Response to United States Environmental Protection Agency Request dated March 8, 2018 on the Back Forty Project Wetland Permit Application

Submittal No. 2NN-5PE0-MT3W USEPA Reference No. WW-16J

Project I.D.: 17A021.18

Re: Response to USEPA March 8, 2018 Comment Letter

Attachments: Figures 1 to 6

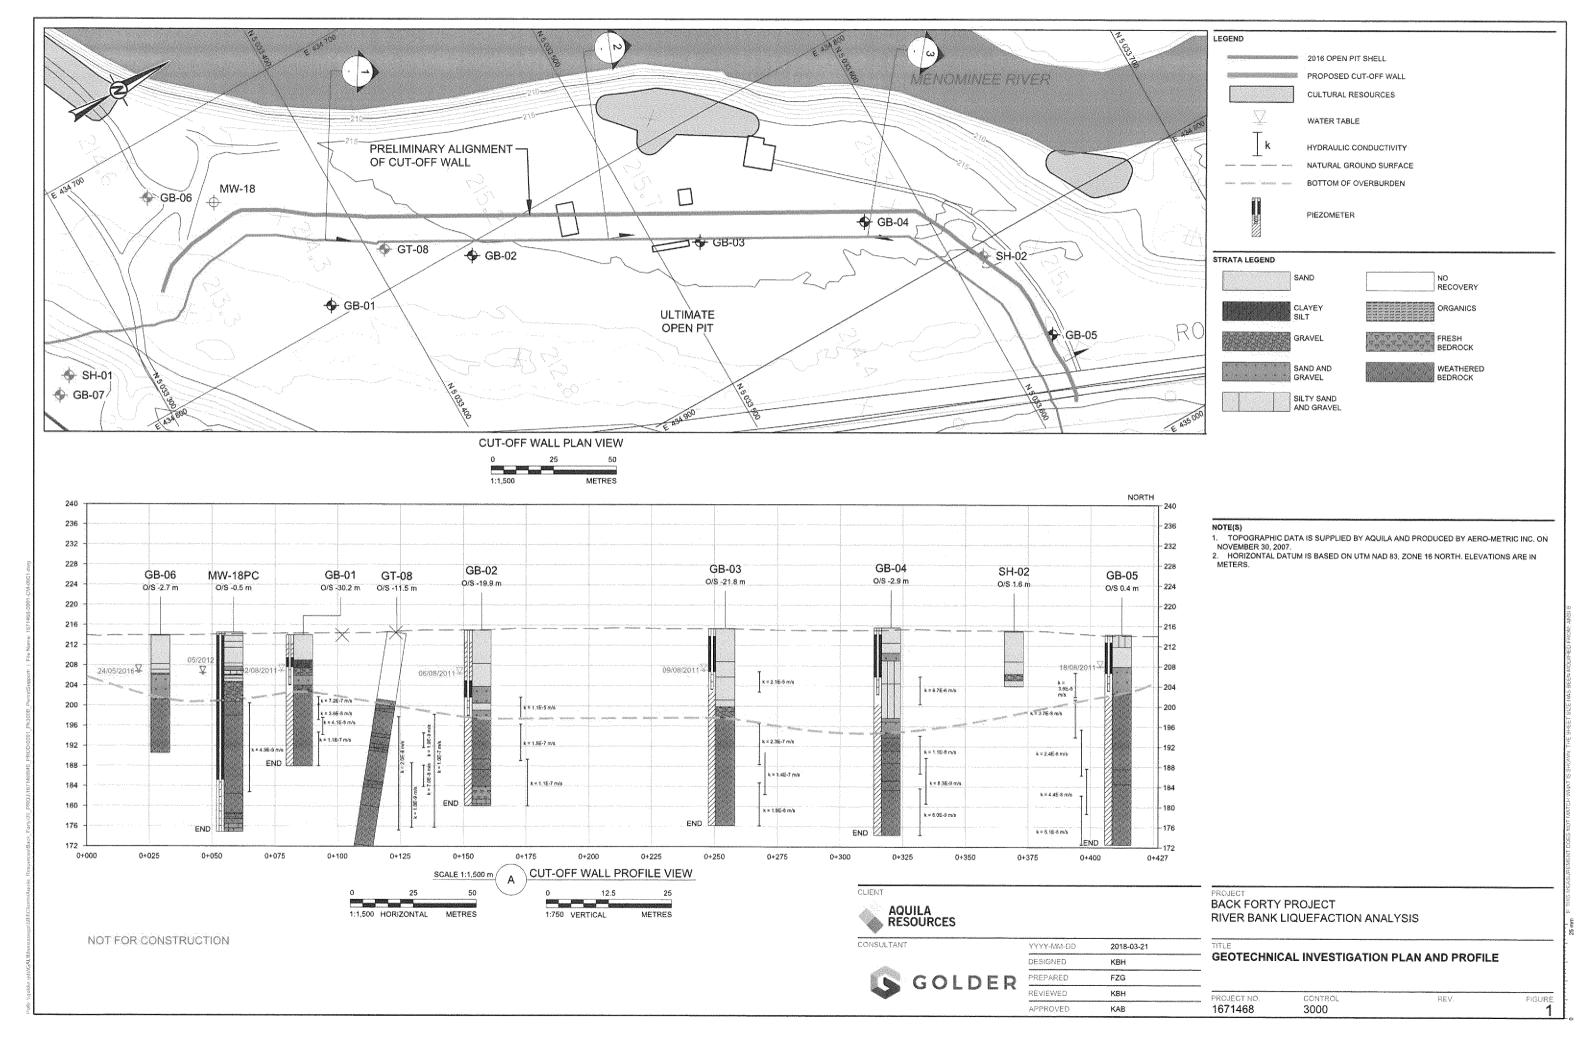
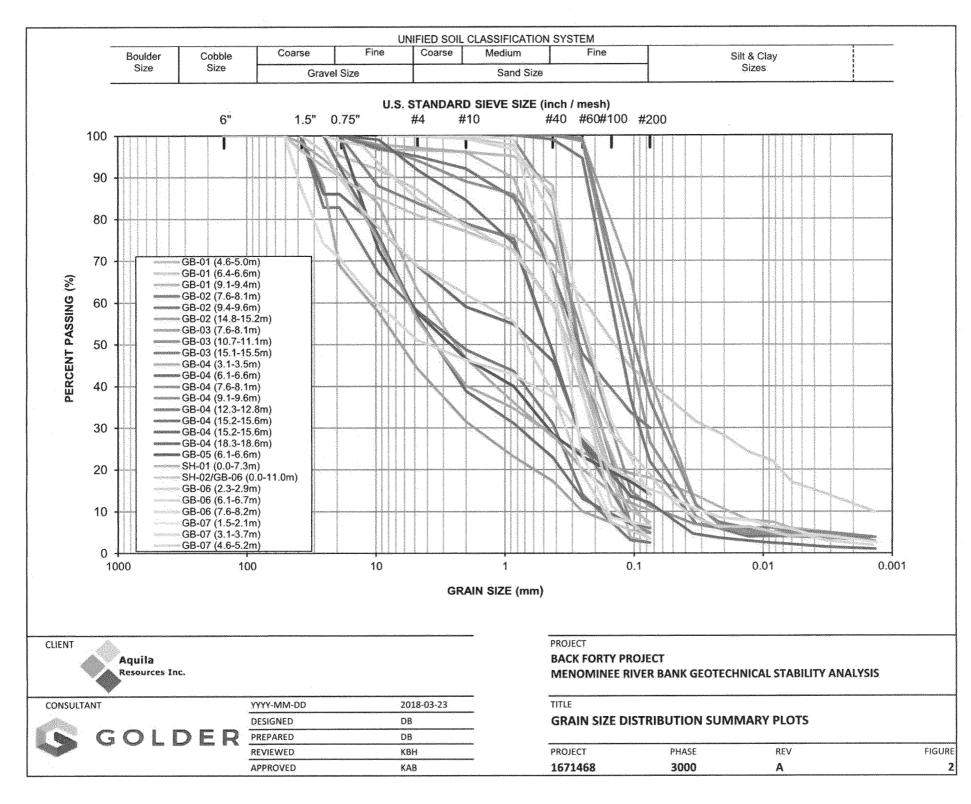
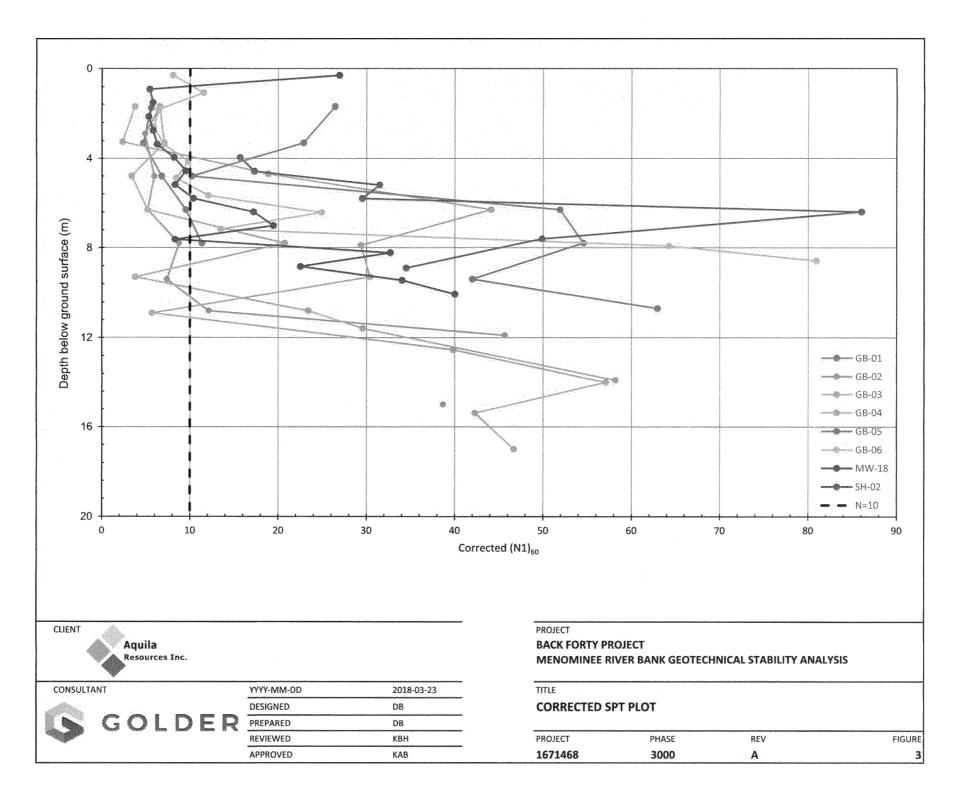
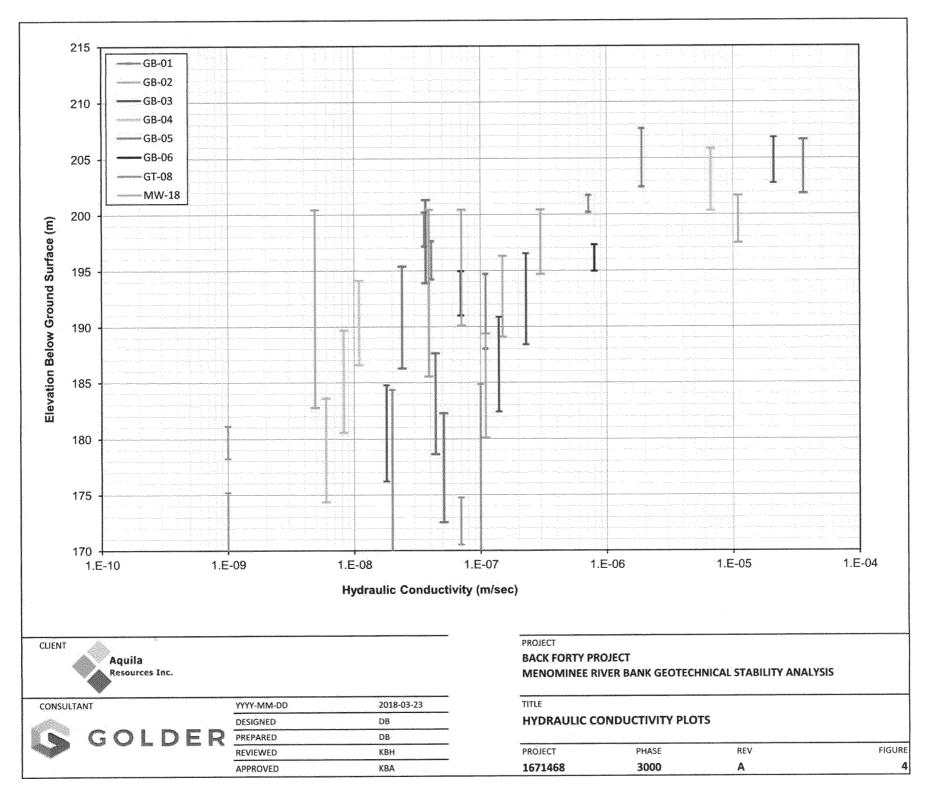
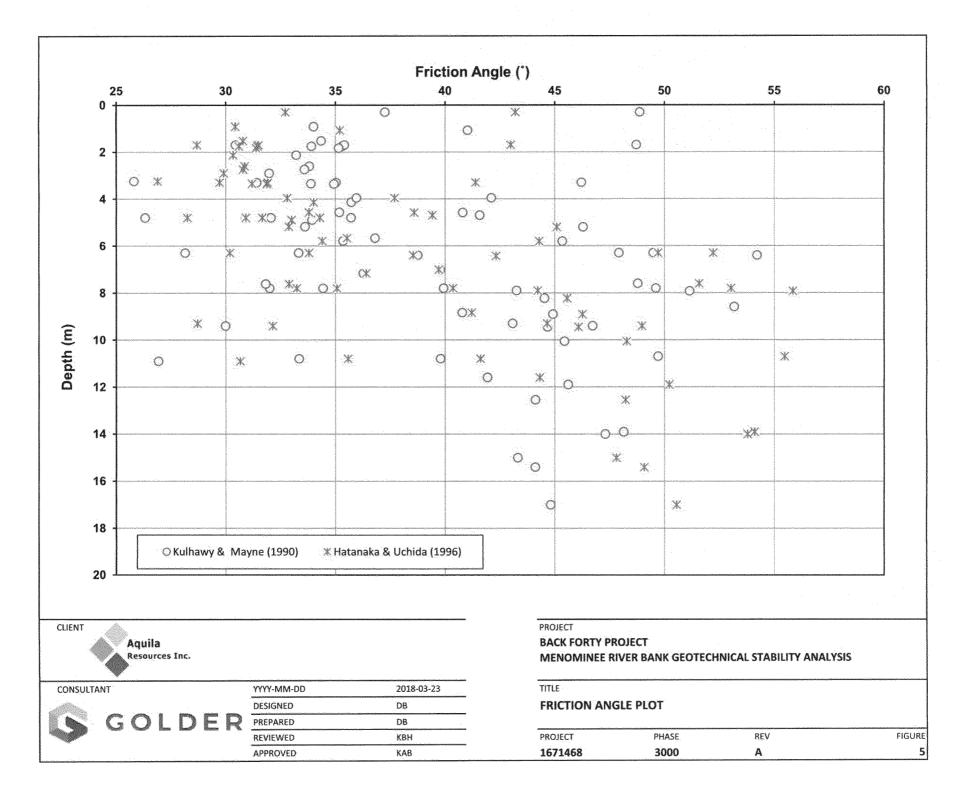
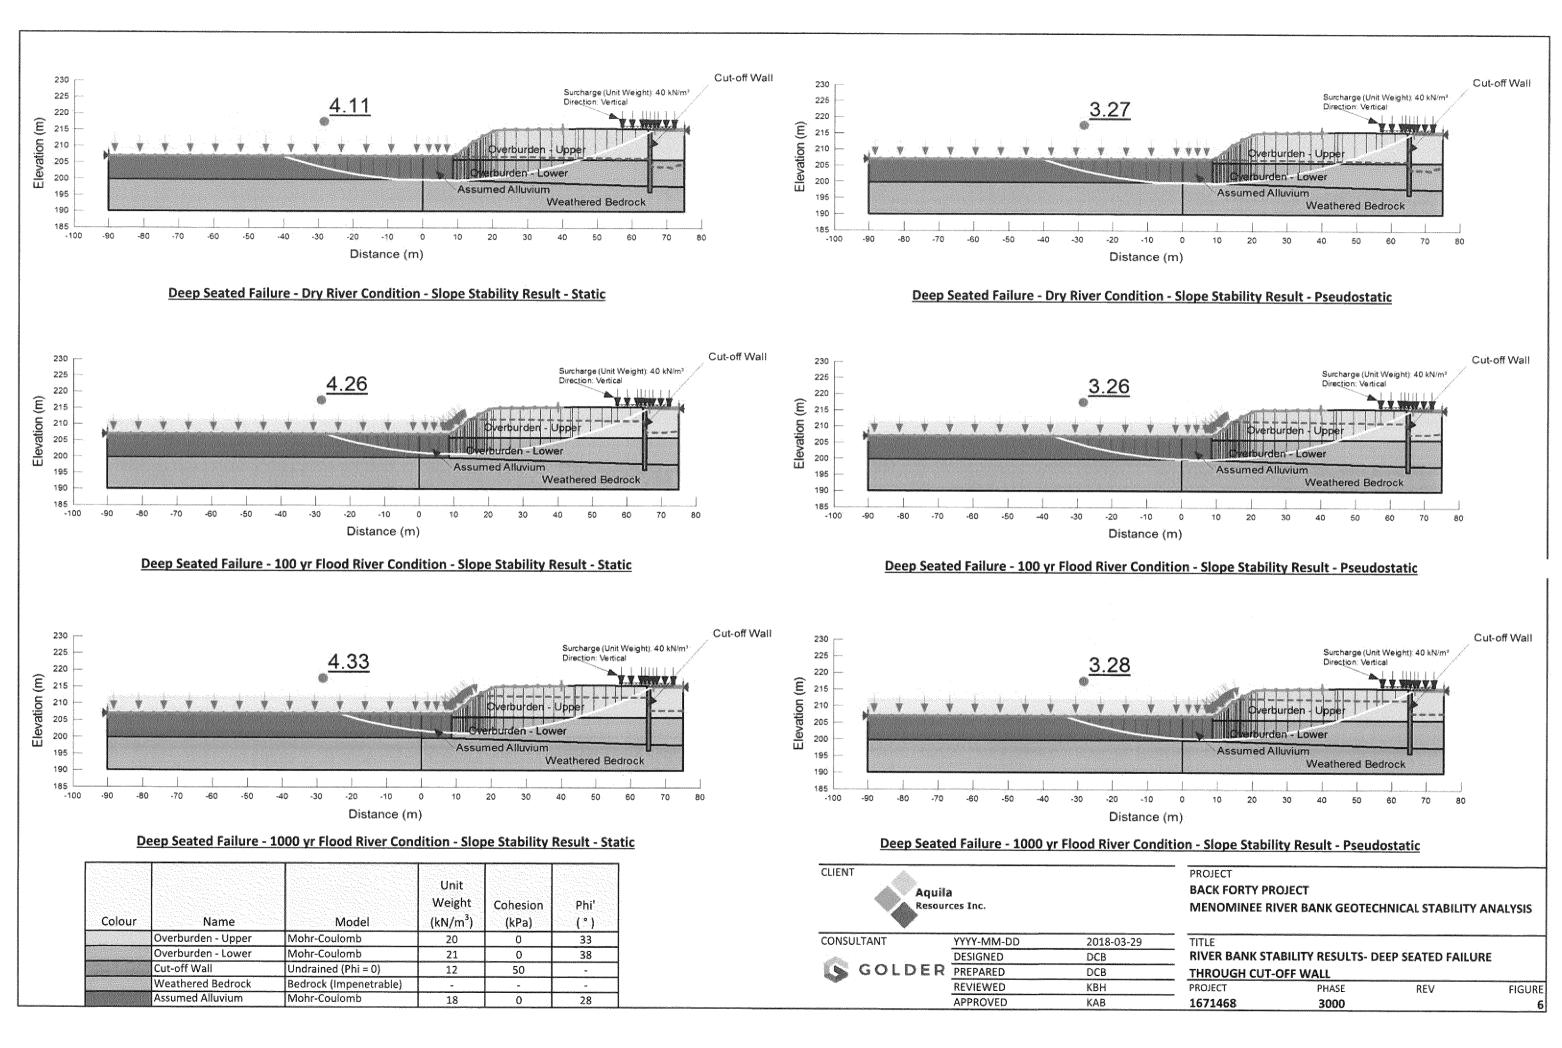
The mine pit is located next to a bluff above the Menominee River and the application currently lacks information that would allow the reviewing agencies to ensure mine pit integrity with respect to the boundary of the river and associated flood plain, including an analysis of slope stability and erosion at the river bank. The application lacks information regarding how the project will include means to stabilize these features, including to address U.S. Fish and Wildlife (and EPA) concerns regarding potential risks to the project and the river from heavy rains. Lack of this information means the reviewing agencies cannot understand the project's potential impact to aquatic resources.

Provide additional documentation of Menominee River bank stability/erosion potential to demonstrate mine integrity.

Three cross-sections shown in Figure 1 were considered for the river bank slope stability analysis. Section 2 was used in the stability analysis it was the most critical of the three cross-sections considered. The subsurface stratigraphy was assigned based on the geotechnical boreholes immediately adjacent to the cross section. The subsurface stratigraphy of the cross section was presumed to extend under the river bed. It was conservatively assumed that the river had eroded to a thalweg corresponding to the top of bedrock and then subsequently infilled with alluvium to its current river bed level.

Deep seated slope stability analyses were carried out through cross-section 2 to assess failure surfaces that passes through the cut-off wall. The results of the stability analyses are summarized in Table 2 and presented in Figure 6. The minimum static FoS of the deep seated failure varied between 4.11 and 4.33, and the minimum pseudo-static FoS varied between 3.26 and 3.28. The blasting operation near the river bank will be controlled to reduce the potential impact on the river bank and the cut-off wall. Therefore, blasting will not have significant impact on the

- The results show that potential deep-seated failures that would compromise the performance the cut-off wall are very improbable. From all the scenarios evaluated, the minimum static and pseudo-static FoS were 4.11 and 3.26, respectively.
- The blasting operation near the river bank will be controlled (e.g. with programmed delays) to reduce the potential impact on the river bank and the cut-off wall. A blast monitoring program will be implemented to confirm that peak particle velocities stay within target values.
- Engineering contingency measures are available if toe erosion results in areas of shallow instability in the river bank during operation. The engineering measures may include placement of rip rap, toe berms, gabion baskets or groins to deflect flow away from the toe of the bank.
